Design Note – DN 001.1

Project: Upper Brook Street Masterplan (pgo-3209-01)
Subject: Escape from Roof Terraces
Date: 25 October 2023
Author: Gareth Ainley
Checked: Adam Monaghan

Figure 3: Building A3 – Level 1

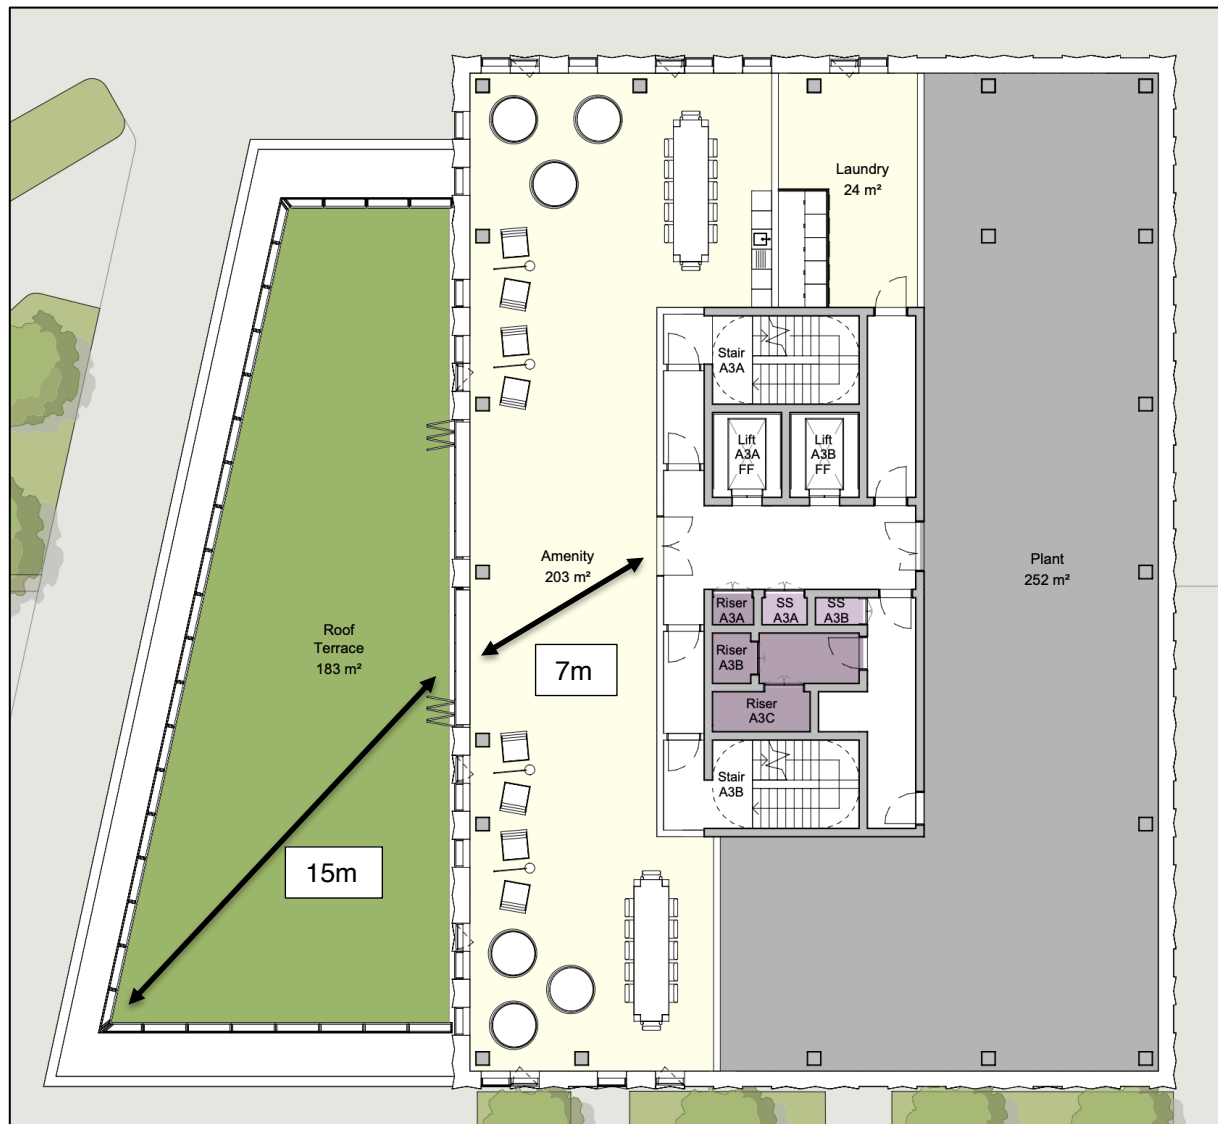
1.7 BS9991:2015, paragraph D.6(a) at Annex 6, states: 'Access to communal roof gardens and similar places should be from a protected stairway enclosure or a protected ventilated lobby/corridor.' Proposed 'A1/A2 General Arrangement Plan – Level 01' shows an unprotected access from the Residents Lounge to Roof Terrace.

noted that in the revised proposals, the terrace at Level 1 in building A1 has been removed. There is still however a similar provision in Building A3.

- There is a high degree of visual awareness between the access rooms and the external terraces. The roof terraces are accessed by bi-fold glazed screens together with windows in the case of Building A3. This means that occupants on the terrace will be readily aware of a fire.

- The access rooms (i.e. the amenity spaces) will be provided with detection throughout the amenity areas. The roof terraces will also have sounders and the fire detection in this space can be configured such that there is a single stage alarm for this area. This will provide early warning of a fire and allow the occupants to evacuate readily.

- The building is provided with sprinklers to BS EN 12845 and the ancillary spaces are protected to an OH 3 category. This should mean that the sprinklers will activate controlling any fire that occurs within the space.

- The access rooms are low risk areas with limited ignition sources. There are no cooking facilities within these areas and whilst there is a kitchenette this does not contain a cooker.

- The travel distances within the enclosed space will be less than 18m thereby reducing the risk of travel that could also contain smoke albeit limited by the measures above. The heights of the ceilings are also 3.5m which extends the time it would take for smoke to fill to the point where the escape routes become compromised.

- The number of occupants on the residents lounge and roof terrace combined will be less than 60 persons. This will reduce the queuing at exits and therefore speed up the time to evacuation. The doors also open in the direction of escape, further addressing this risk.

For the terrace area in Building A3, the rationale in Section 2 has been followed in the alternate approach and we ask that this be considered in the review.
